WHEELCHAIR LIFT FLOOR REINFORCEMENT

RETROFIT: RETRO – 0095
Instruction: N/A
EPN:0713-00

LION		
Date:	2020-11-25	Version:	01
Subject:	RETROFIT: RETRO – 0095		
Year / Make / Models affected:	2016 -02019 Lion LionC/Lion360	NHTSA Recall#:	20V-697
Problem:	The wheelchair anchors had torn the floor beam when we passed the CMVSS 222.		
Remedy:	Structural rivets need to be added to stiffener the beam and pass the CMVSS 222.

1. FLOOR REINFORCEMENT

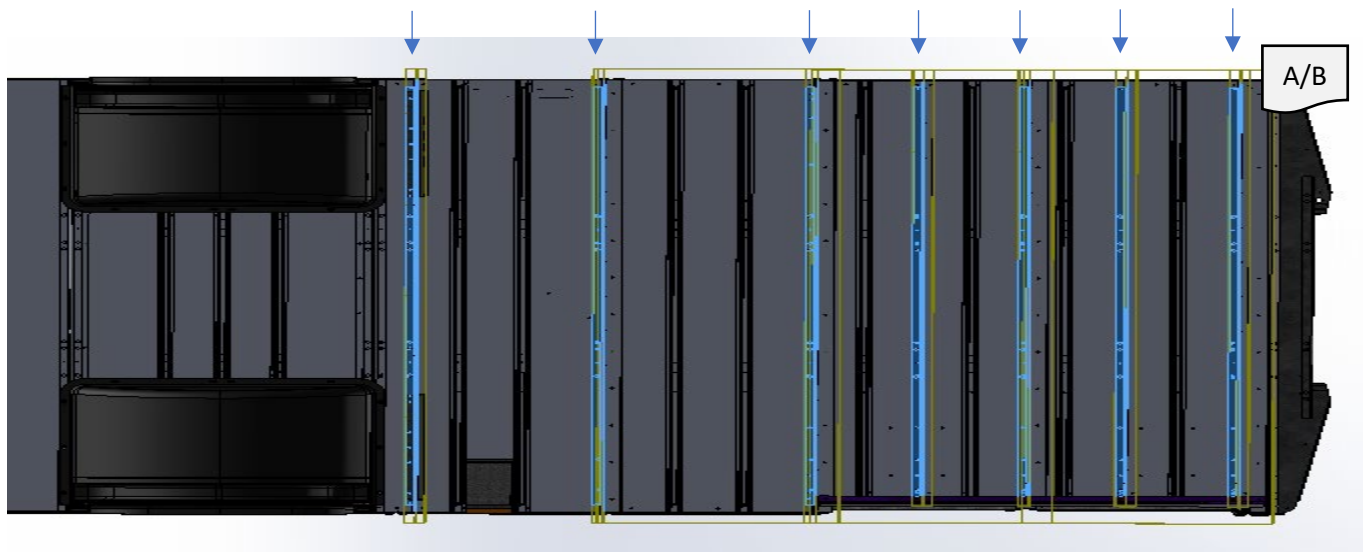
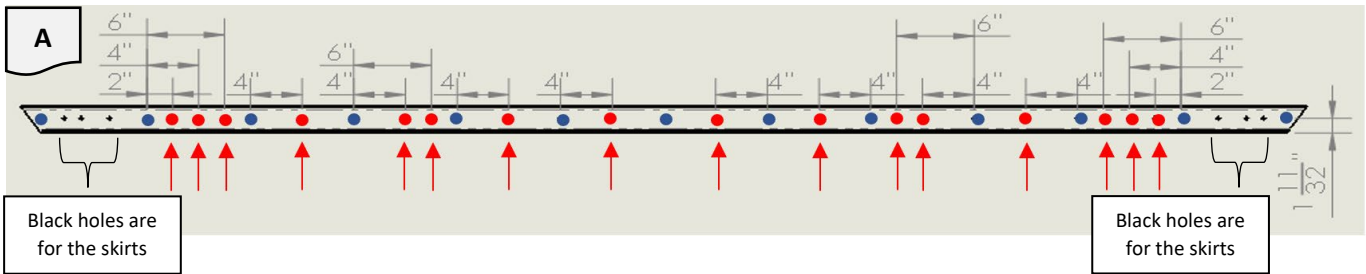
Rev 01 – 14-08-20 Add six (6) holes and rivets/bolts to the floor's C channels

A	Drill 16 holes with drill bit F at the locations identified by red dots and arrows and at 1 11/32" from the bottom of the C channel. The blue dots represent the rivets already on the C channel.
B	Install 16 1/4 rivets (14810730) on each C channel (7) behind the wheelhouses.
Option 2 (Bolt and Nut):	
A	Drill 16 holes with drill bit 25/64" at the locations identified by red dots and arrows and at 1 11/32" from the bottom of the C channel. The blue dots represent the rivets already on the C channel.
B	Install 16 bolts 3/8-16 (14802478) and nuts 3/8-16 (14800516) on each C channel (10) identified below. Apply a torque of 31 ft-lbs in dry condition.

OPTION 1
14810730 (16x) on each C channel

OPTION 2
14802478 (16x) and 14800516 (16x)
on each C channel
